RE: **Lot 18 Block 5 Unit 18 Volcano Cliffs SAD 228**  
**6624 Sujeto NW**  
**Grading and Drainage Plan**  
**Engineers Stamp Date 7/18/17 (D10D003K18)**

Based upon the information provided in your submittal received 7/19/17, this plan cannot be approved for Grading Permit until the following comments are addressed.

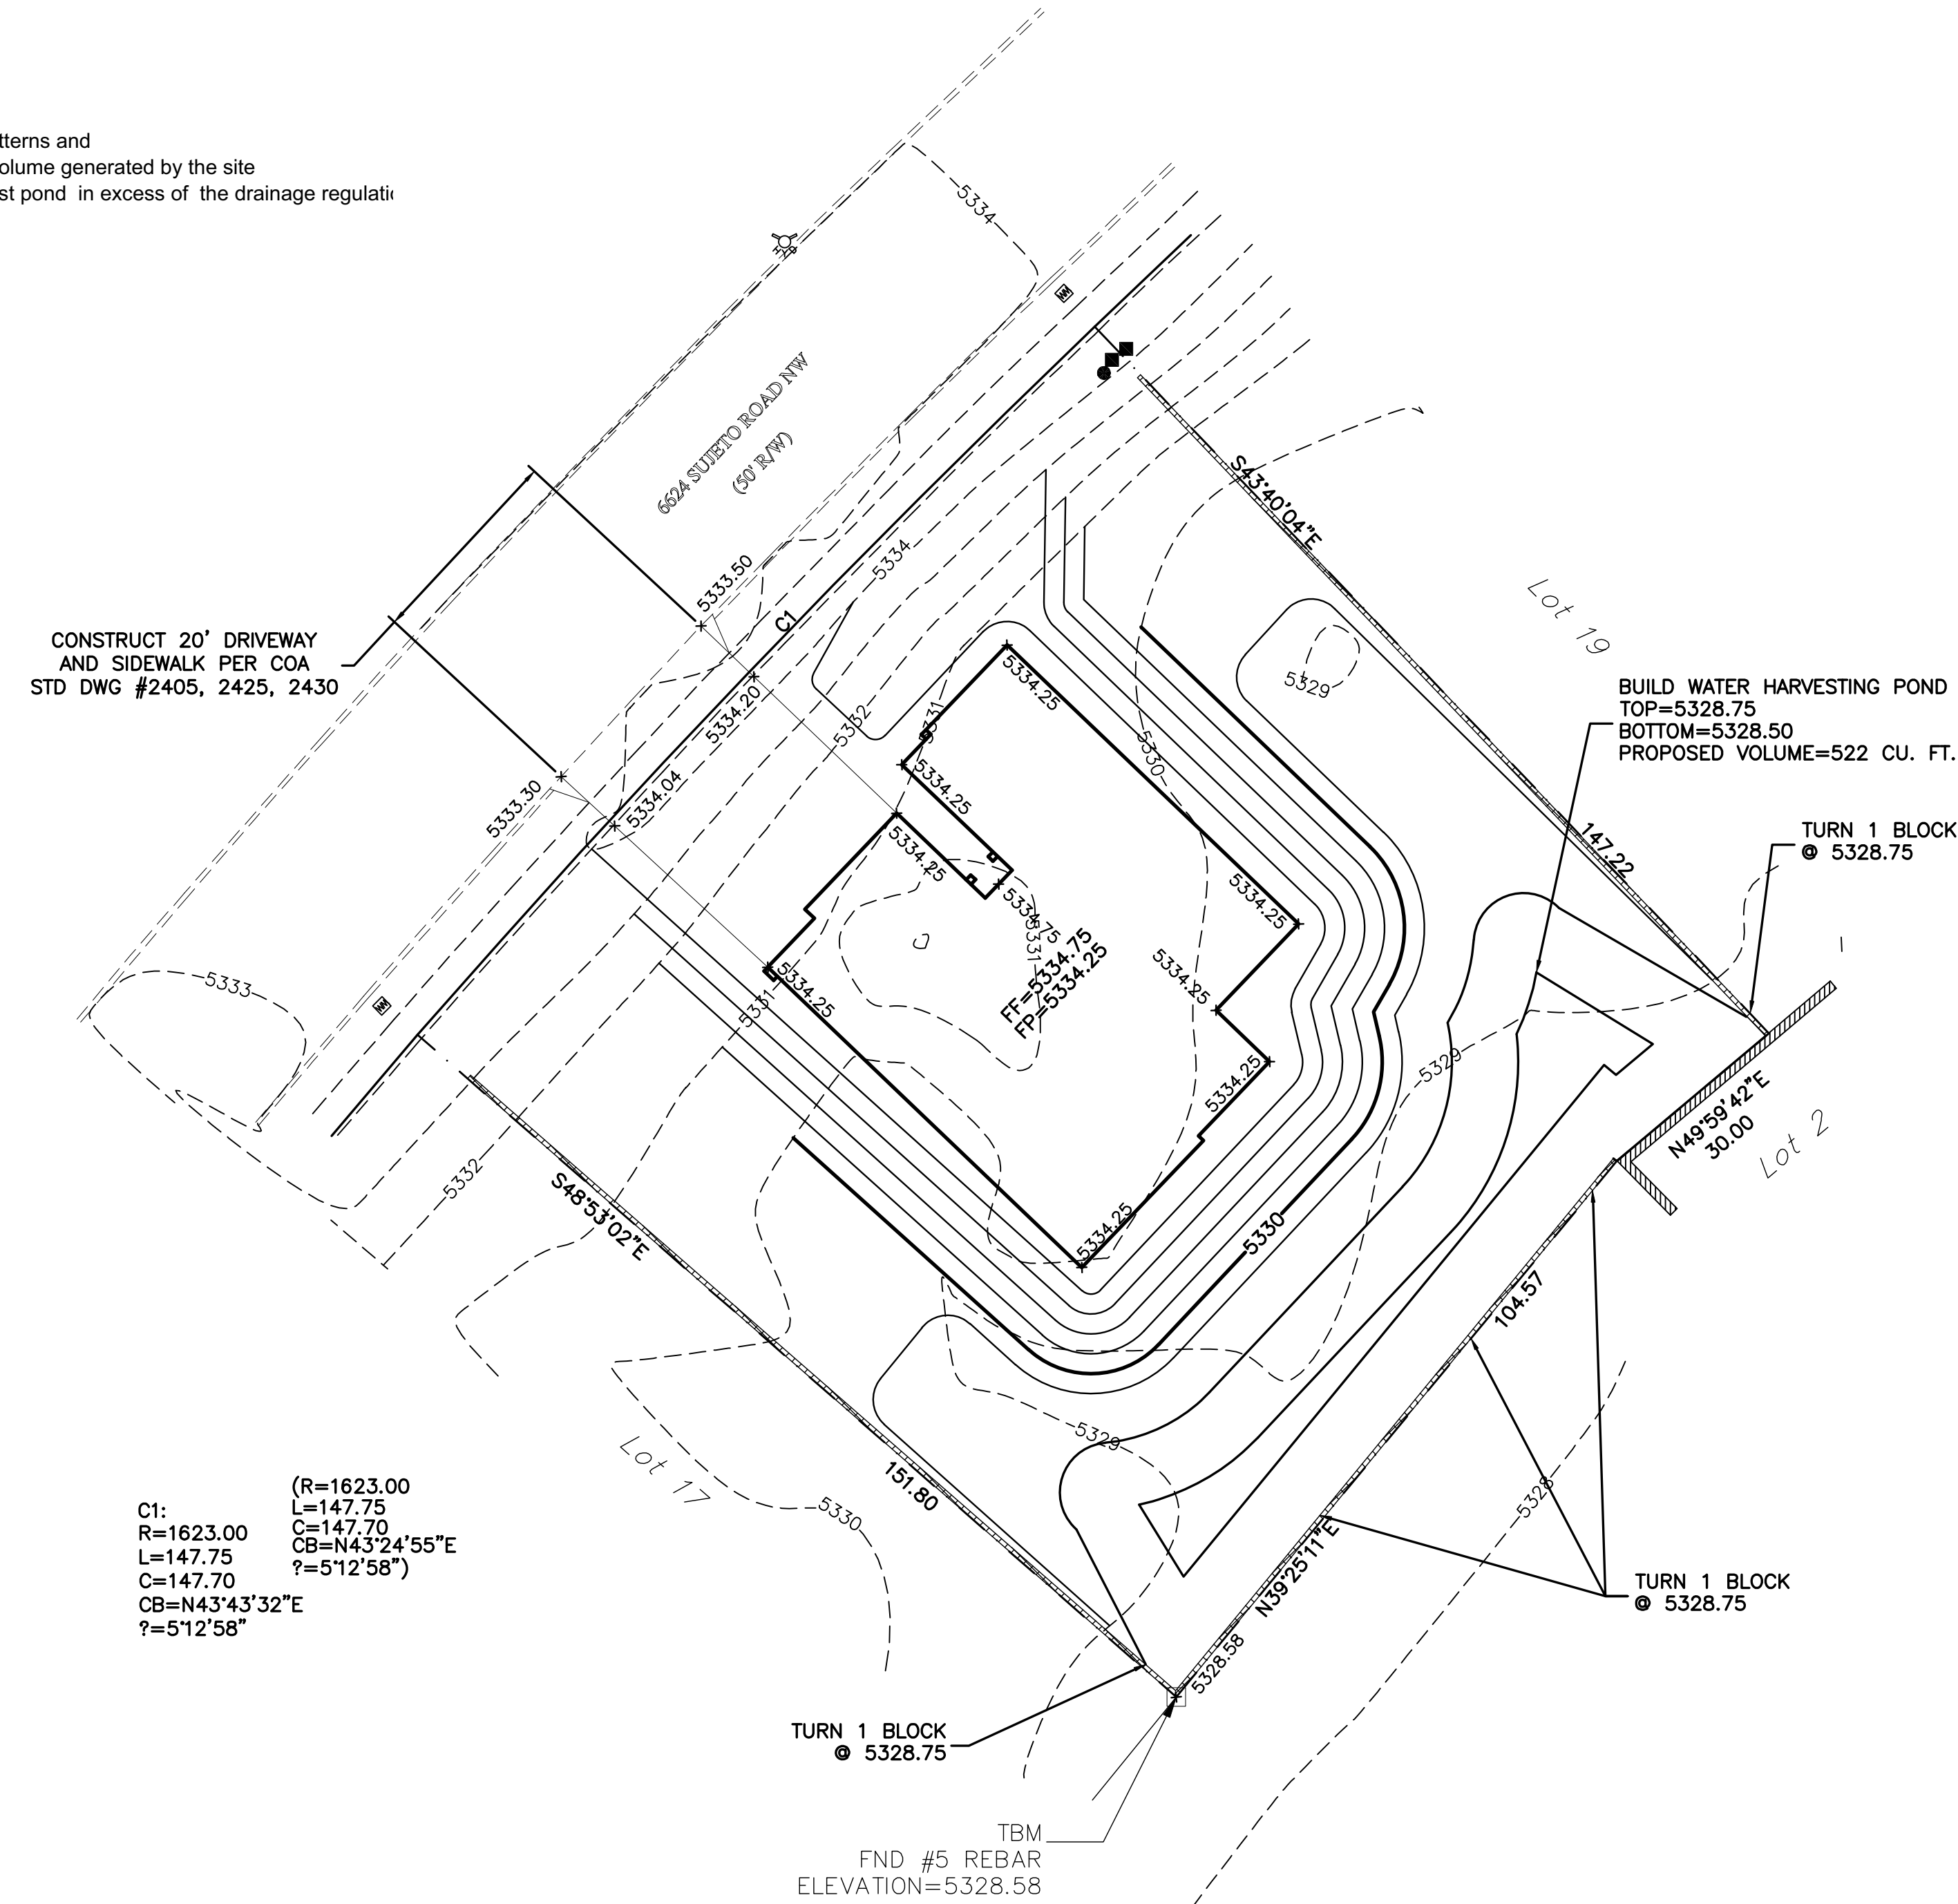
- Provide calculations for the openings in the walls.
- Show the 7 foot P.U.E.
